SERVICE LETTER NO. SL-1

EFFECTIVITY: Rockwell Commander 112 S/N 3 through 79

SUBJECT: Rudder Assembly

SECT A-A

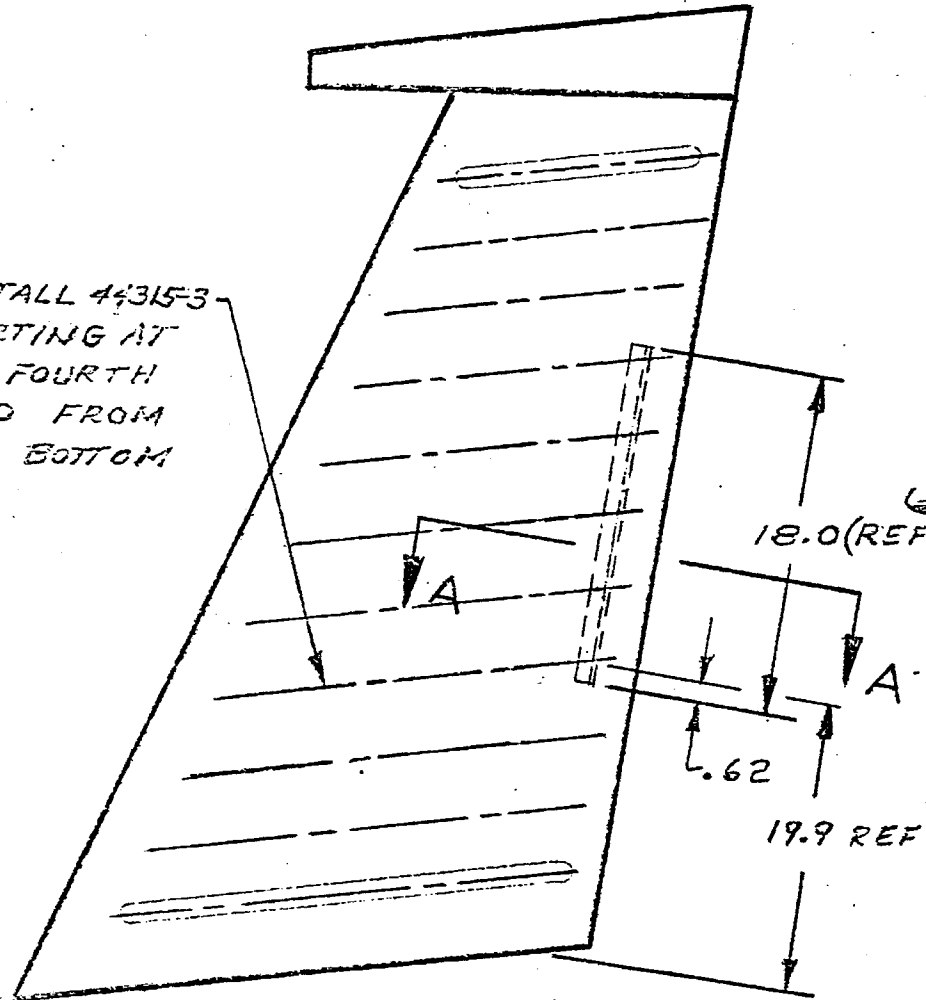
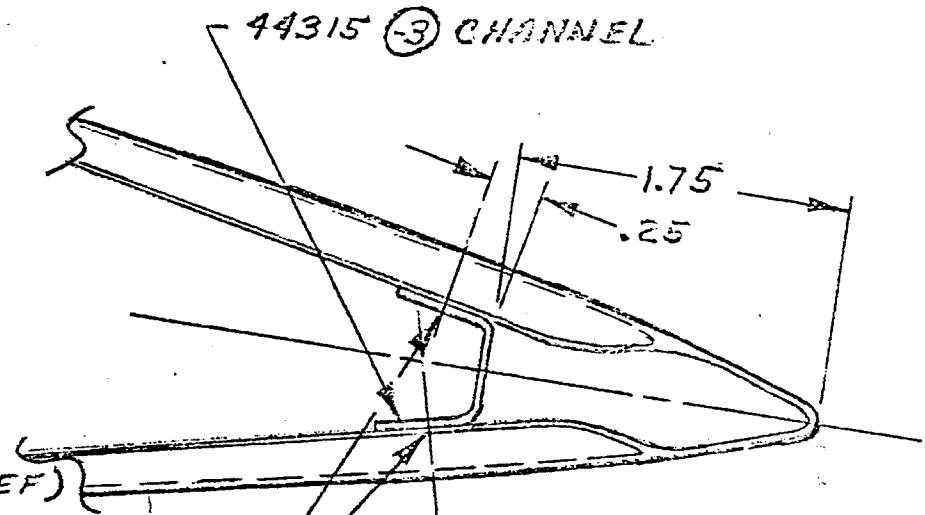
2. Remove rudder.
3. Drill top and bottom rivet holes on both sides of rudder.
4. Mark rivet center line on channel then mark locating line for one of the rivets.
5. Insert channel through lightening hole on the leading edge of rudder and position channel so that center line for one end rivet is visible through rivet hole. Drill and cleco.

6. Position channel so that rivet line is centered in the remaining hole. Drill and cleco.
7. Drill remaining holes through rudder skin and channel, then rivet.
8. Paint rivet heads with minimum amount of touch up paint.
9. Check balance of rudder and rebalance if necessary.
10. Replace rudder adding AN960-416L washer under head of lower hinge bolt.
11. Make the following entry in the Airframe Logbook:

INSTALL 44315-3
STARTING AT
THE FOURTH
BEAD FROM
THE BOTTOM

CR 2249-4-1 CHERRY RIVET
10 REQ

Figure 1.

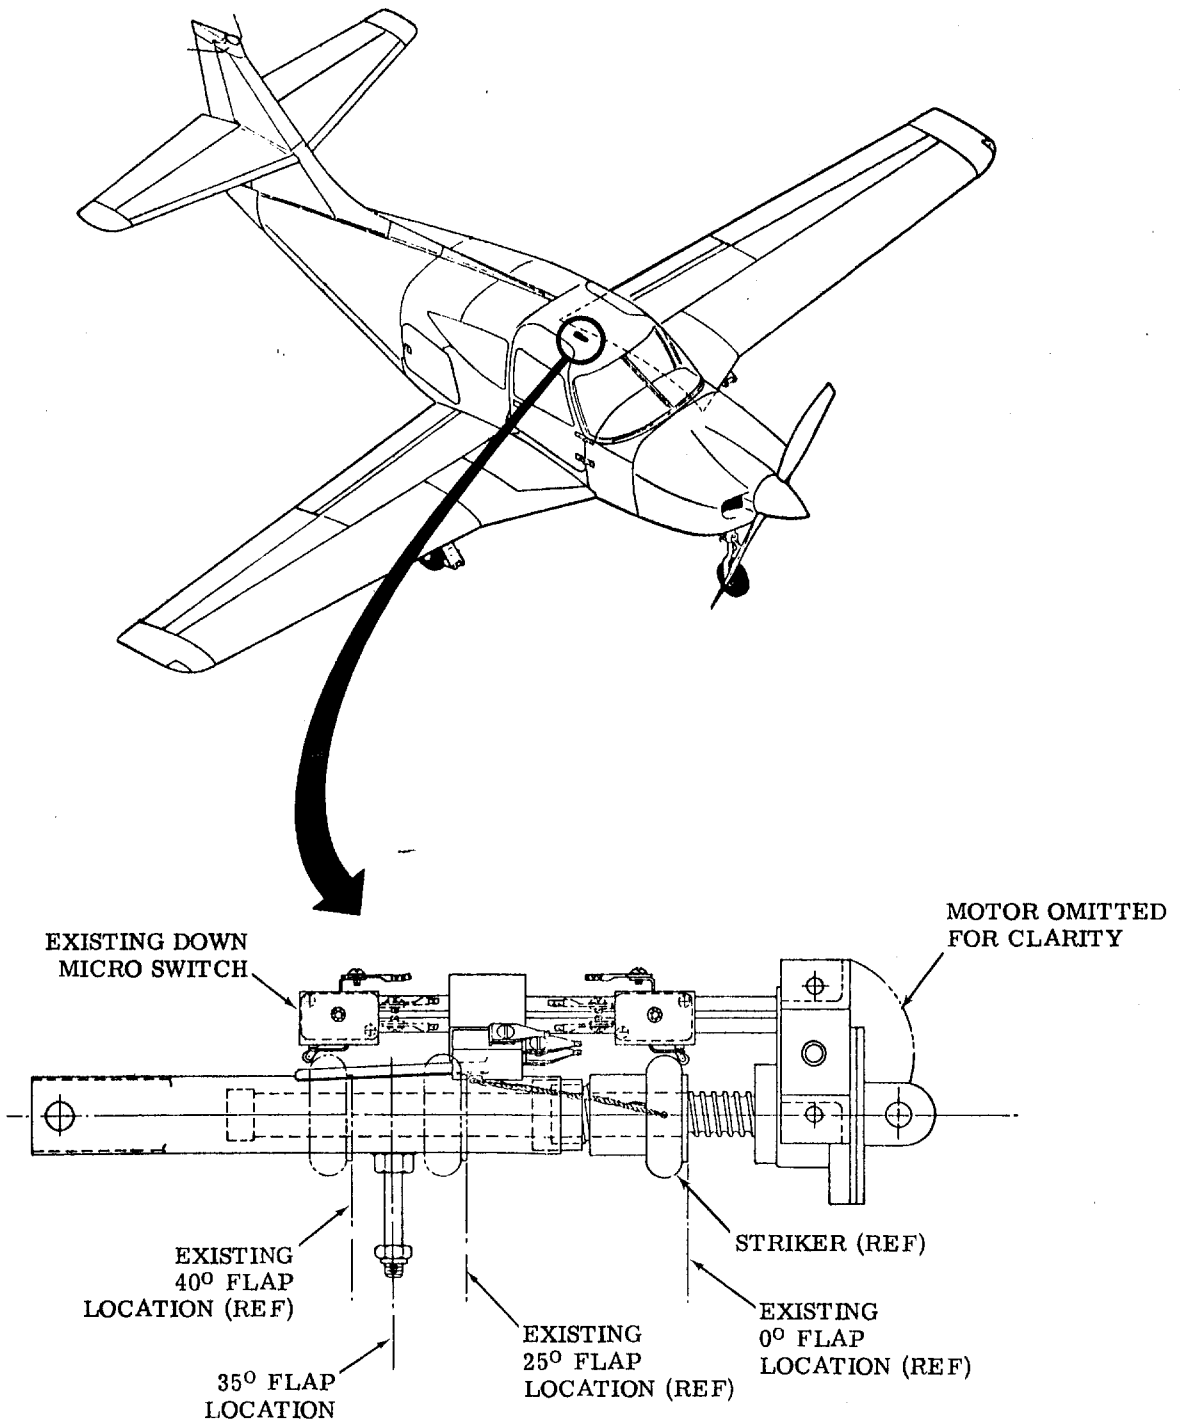
7. Install SW-407370-3 bezel on flap position indicator.
8. Reidentify reworked flap position indicator to 304AA-35.
- i. Reinstall reworked airspeed indicator and flap position indicator (if removed) in aircraft.
- j. Remove seats, carpet and floor panels as necessary to gain access to flap actuator switches located beneath floor between fuselage Sta. 127.25 and Sta. 144.26.

Figure 1.

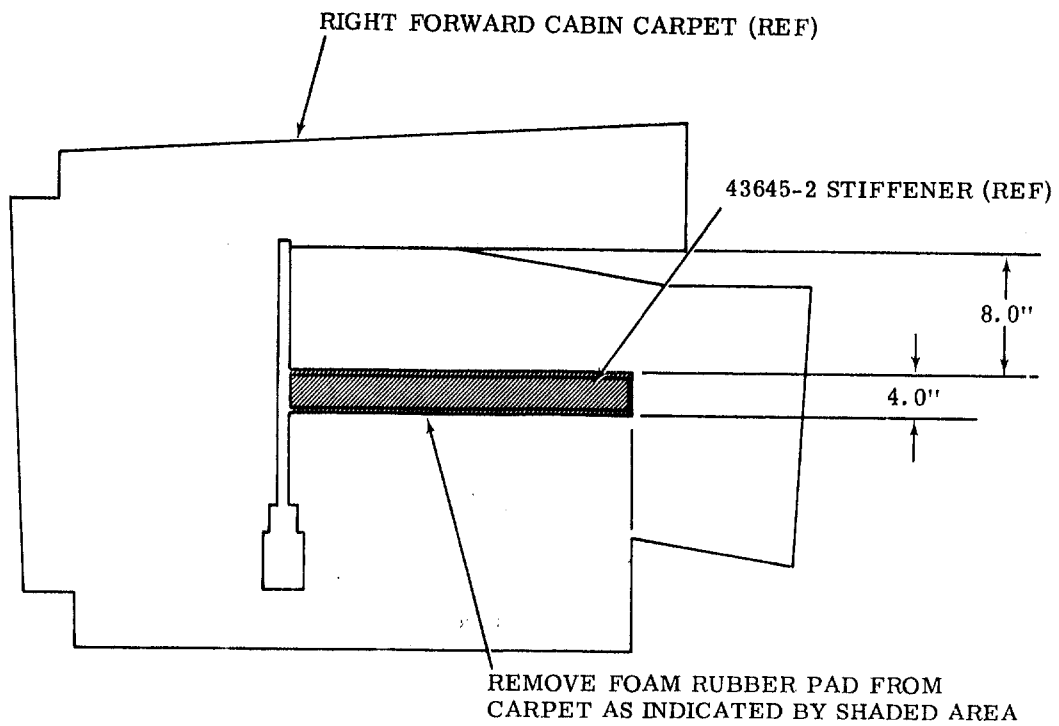
- a. Remove existing scuff plate from right forward cabin carpet.
- b. Remove existing carpet from right forward cabin floorboard.
- c. Remove any remaining glue from floorboard.
- d. Locate and install 43645-2 stiffener on right forward cabin floorboard using #1300-3M Scotch Grip Adhesive (see Figure 1.).
- e. Remove foam rubber pad from carpet in area shown in Figure 1.
- f. Reinstall existing right forward cabin carpet using 3642A Tuf-Grip Adhesive.
- g. Reinstall existing scuff plate on right forward cabin carpet.

Figure 1.

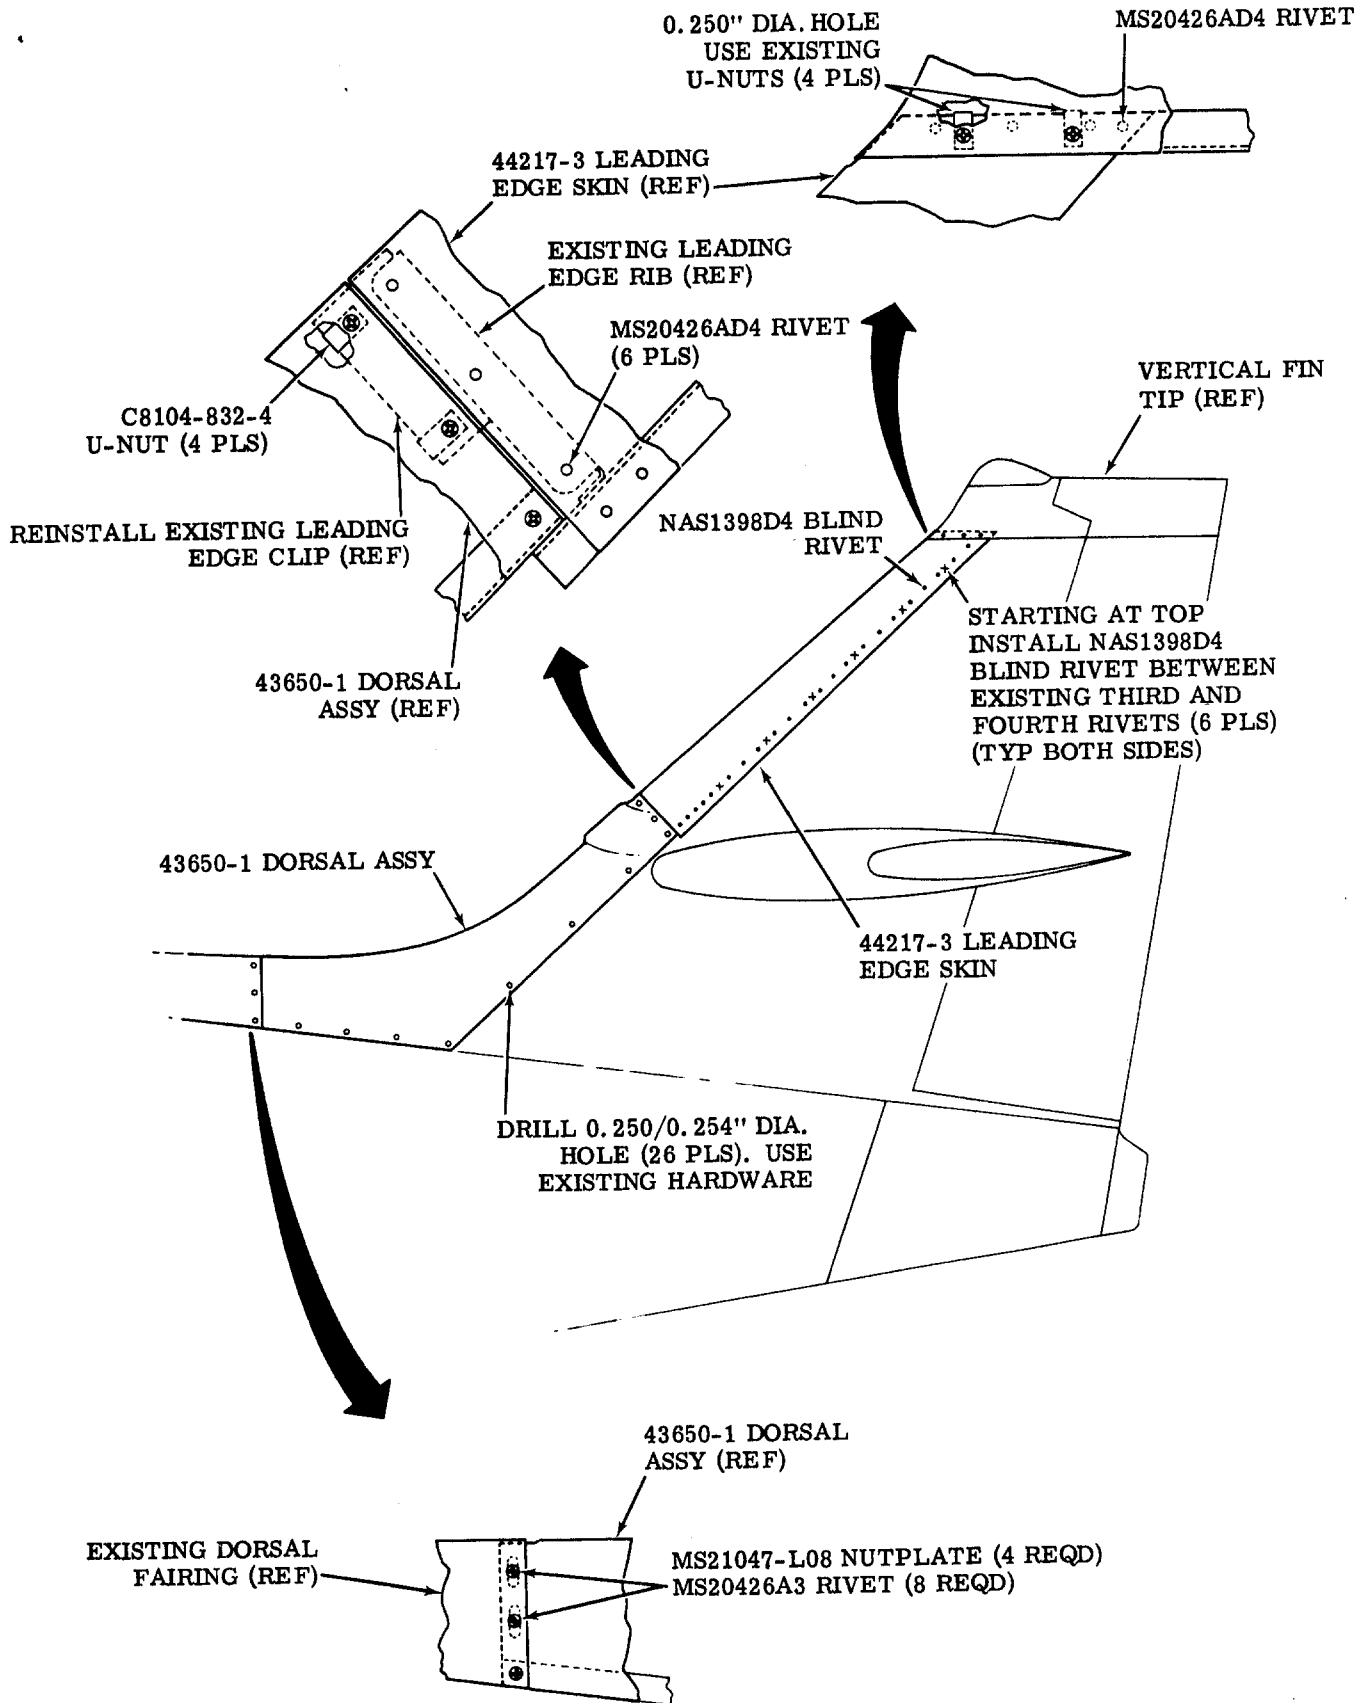
- a. Remove existing vertical fin tip.
- b. Remove and discard existing upper vertical fin leading edge skin and dorsal assembly.
- c. Locate, drill and install 44217-3 leading edge skin and existing leading edge clip on aircraft (see Figure 1.).
- d. Locate 43650-1 dorsal assembly on aircraft and trim to fit.
- e. Using a hole finder, drill twenty-six (26) 0.252 (\pm 0.002) inch diameter holes in dorsal assembly to match holes in aircraft skin (see Figure 1.).
- f. Install MS21047-L08 nutplate (4 places) on dorsal assembly (see Figure 1.).
- g. Install 43650-1 dorsal assembly on aircraft using existing screws, washers and four (4) C8104-832-4 U-nuts (see Figure 1.).
- h. Reinstall existing vertical fin tip.

- a. Remove existing vertical fin tip.
- b. Remove and discard existing upper vertical fin leading edge skin.
- c. Disconnect radio antenna leads from dorsal assembly and remove and discard existing dorsal assembly.
- d. Locate and drill a 0.128-inch diameter hole in 44217-3 leading edge skin and drill and install 48732-1 stiffener (see Figure 1.).
- e. Locate, drill and install 44217-3 leading edge skin and existing leading edge clip on aircraft (see Figure 1.).
- f. Locate 43650-1 dorsal assembly on aircraft and trim to fit.
- g. Using a hole finder, drill twenty-six (26) 0.252 (\pm 0.002) inch diameter holes in dorsal assembly to match holes in aircraft skin (see Figure 1.).
- h. Install MS21047-L08 nutplate (4 places) on dorsal assembly (see Figure 1.).

Figure 3.

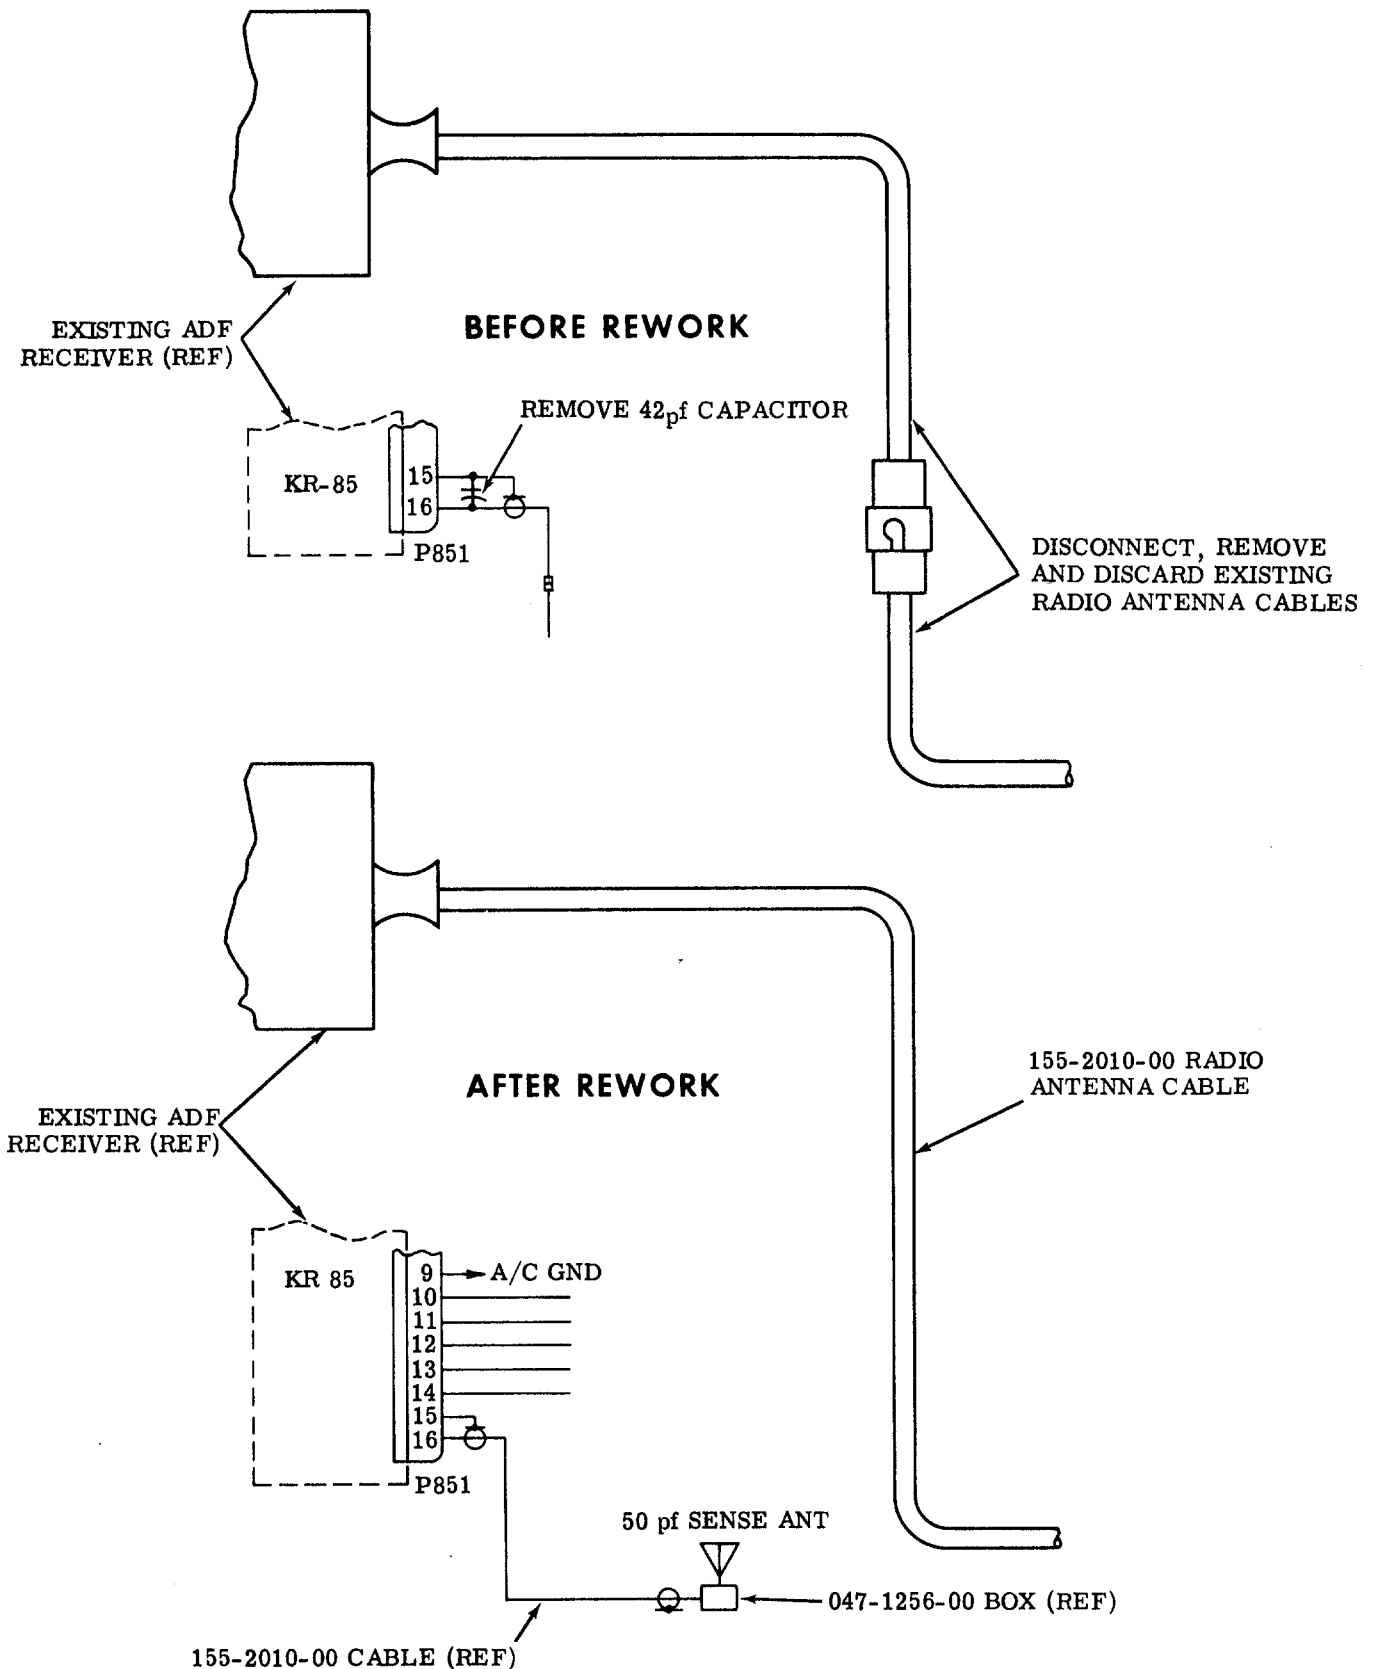
- i. Remove interior overhead paneling as necessary to gain access to radio antenna cable.
- j. Remove and discard existing overhead radio antenna cable.
- k. Install 43650-1 dorsal assembly on aircraft using existing screws, washers and four (4) C8104-832-4 U-nuts (see Figure 1.).
- l. Reinstall existing vertical fin tip.
- m. Locate and drill two (2) 0.187-inch diameter holes and one (1) 0.437-inch diameter hole in top of fuselage skin at Sta. 130.00 (see Figure 2.).
- n. Install 071-1007-00 radio antenna kit (see Figure 2.).
- o. Install 155-2010-00 antenna cable (see Figure 3.).
- p. Reinstall interior overhead paneling.

Figure 1.

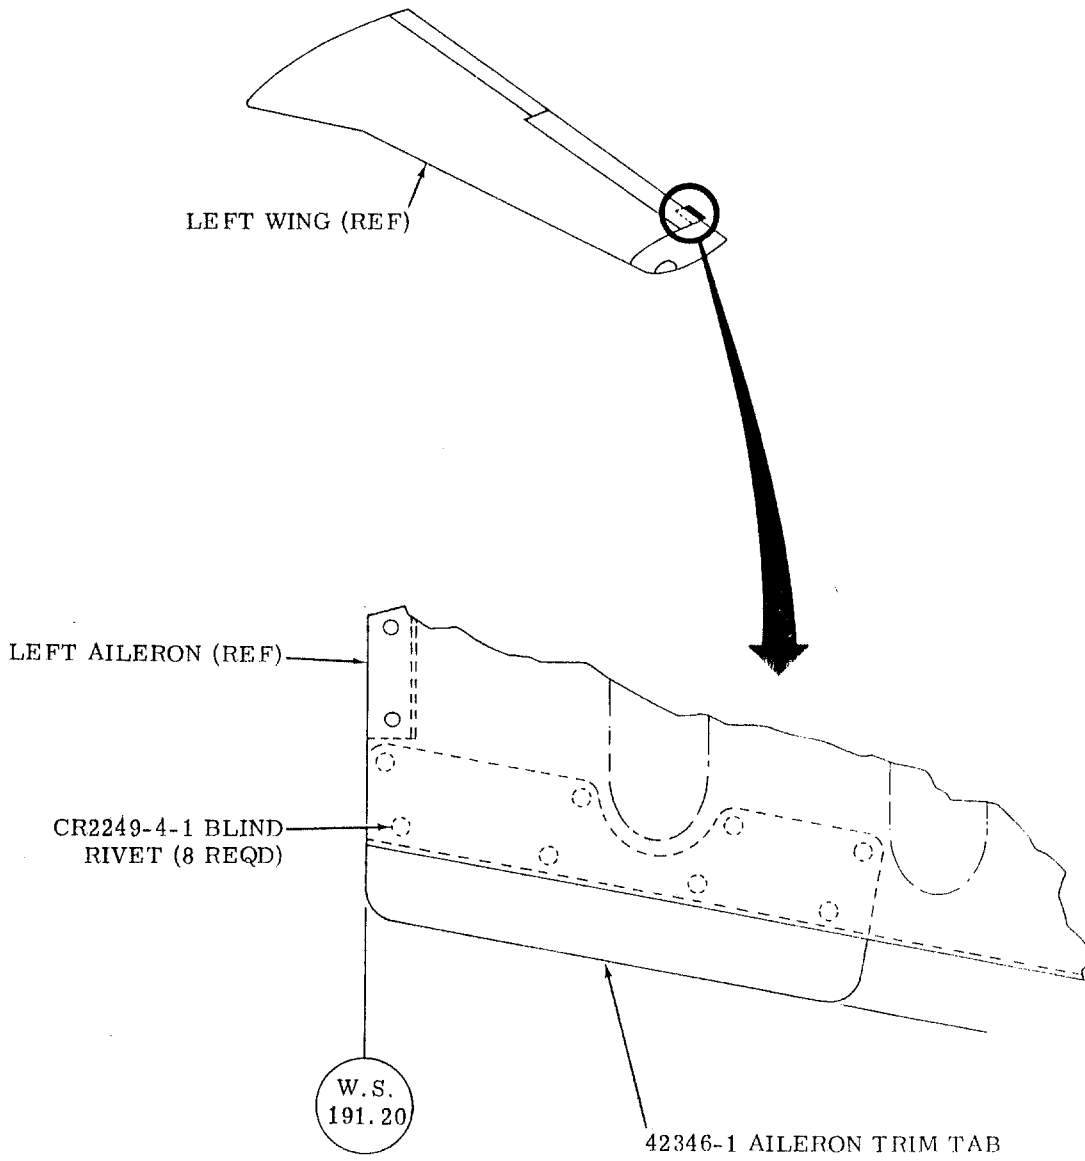
- a. Using 42346-1 aileron trim tab as template, locate, drill and install aileron trim tab on lower outboard surface of aileron (see Figure 1.)
